FINAL REPORT

Clarksburg - Ten Mile Creek Area Sewer Facility Study

WSSC Contract PM0007A07

Washington Suburban
Sanitary Commission

**Figure 4-2
Comparison of Pump Station Sizes**

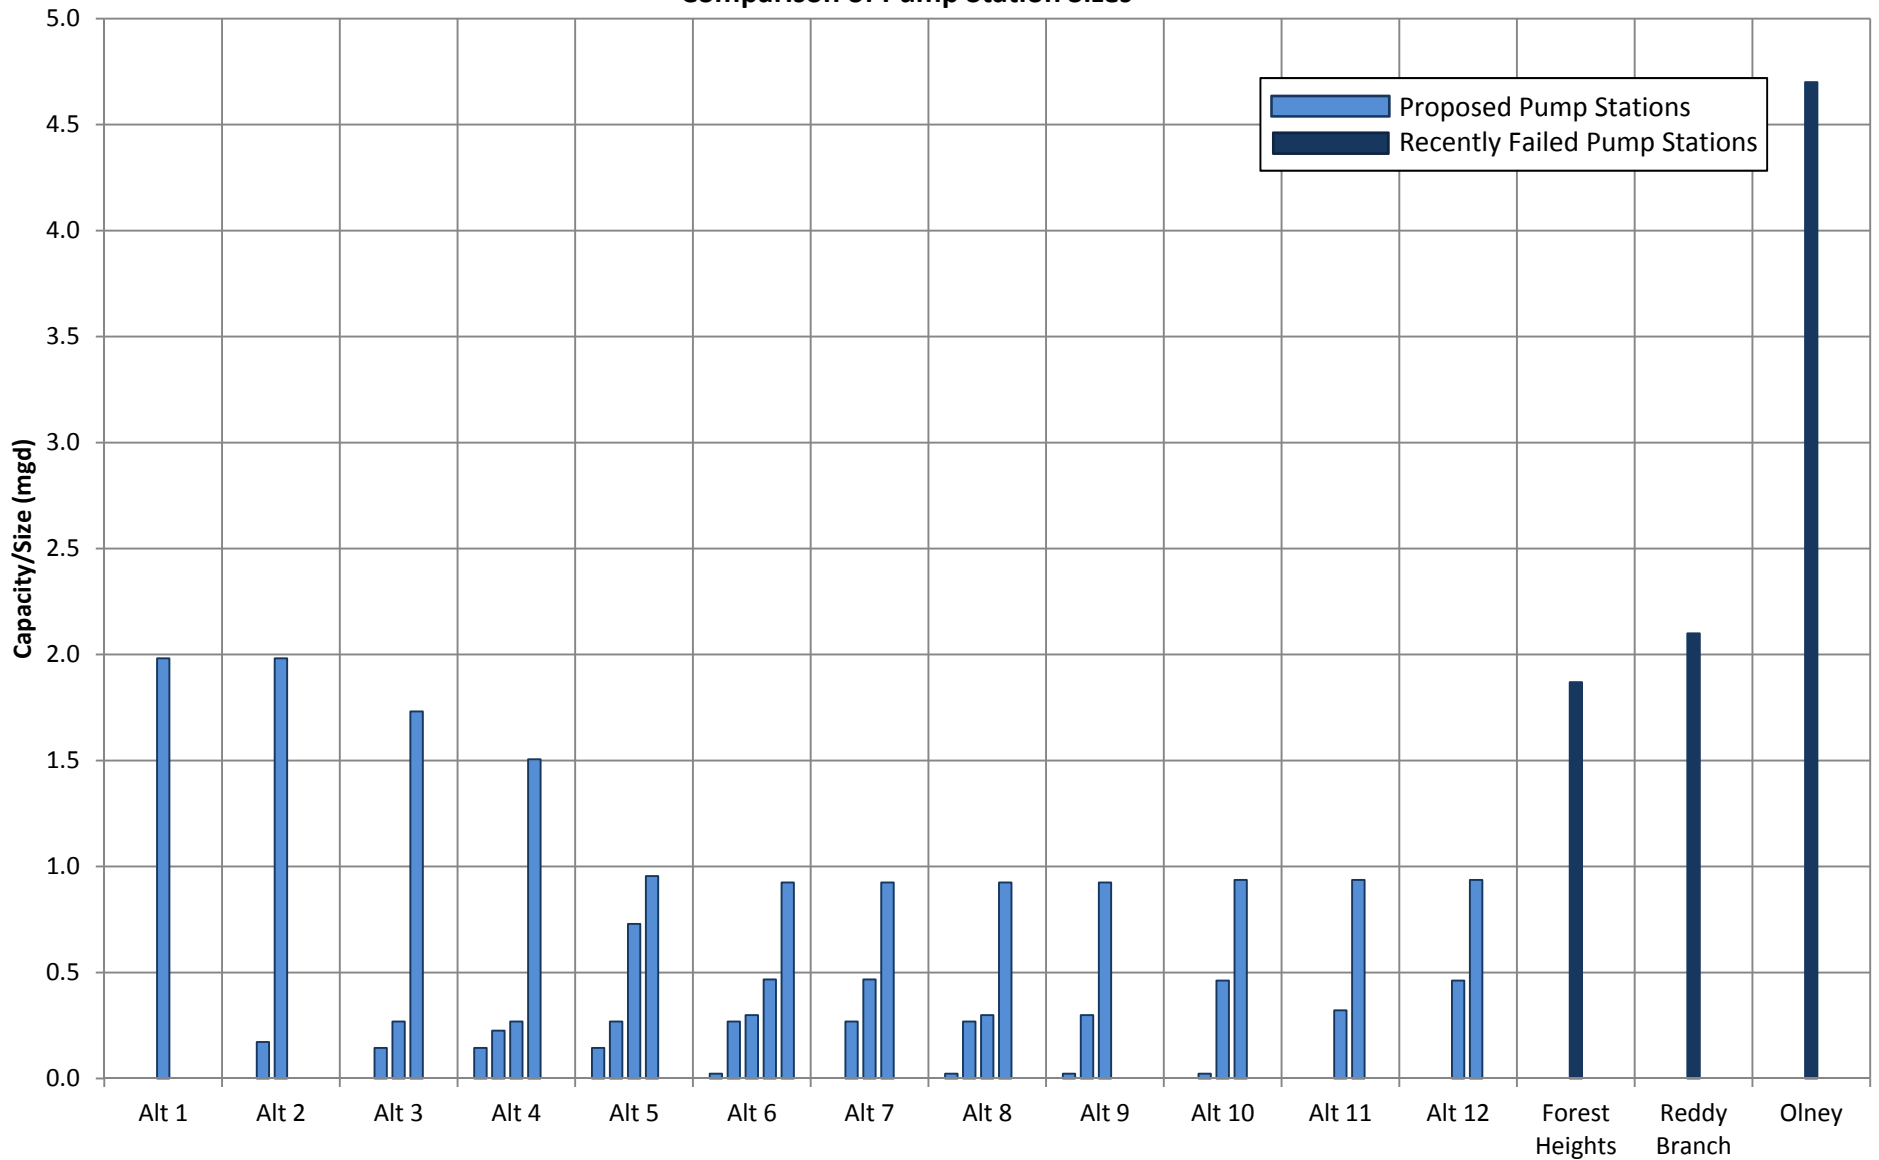
2	12/21/2015	Katherine E. Nelson Planner Coordinator M-NCPPC	<i>11. Figure 4-1 and 4-2 pages 4-14 and 4-15 – Should identify “recently failed” pump stations rather than “existing” pump stations. It implies that these are the only pump stations in the WSSC system.</i>	Revised figures 4-1 and 4-2 in the Final Draft Report to address the comment.
53	12/21/2015	Katherine E. Nelson Planner Coordinator M-NCPPC	<i>12. Figure 4-3 and 4-4 (the Preferred Approaches) – The graphics reference “Grinder Systems” and “grinder pump solution”, but the legend identifies “Low Pressure Sewer”. One term should be used when describing these systems, both on these graphics and in the text.</i>	Revised figures in the Final Draft Report to address the comment.
54	12/21/2015	Katherine E. Nelson Planner Coordinator M-NCPPC	<i>13. Criteria for the successful use of low pressure sewers should be provided by this study. At a minimum, examples of the successful use of low pressure sewers should be provided.</i>	Refer to WSSC SP ENG-04-10, Grinder Systems Policy and Procedure, as to successes we have achieved based on experience and meeting policy requirements.
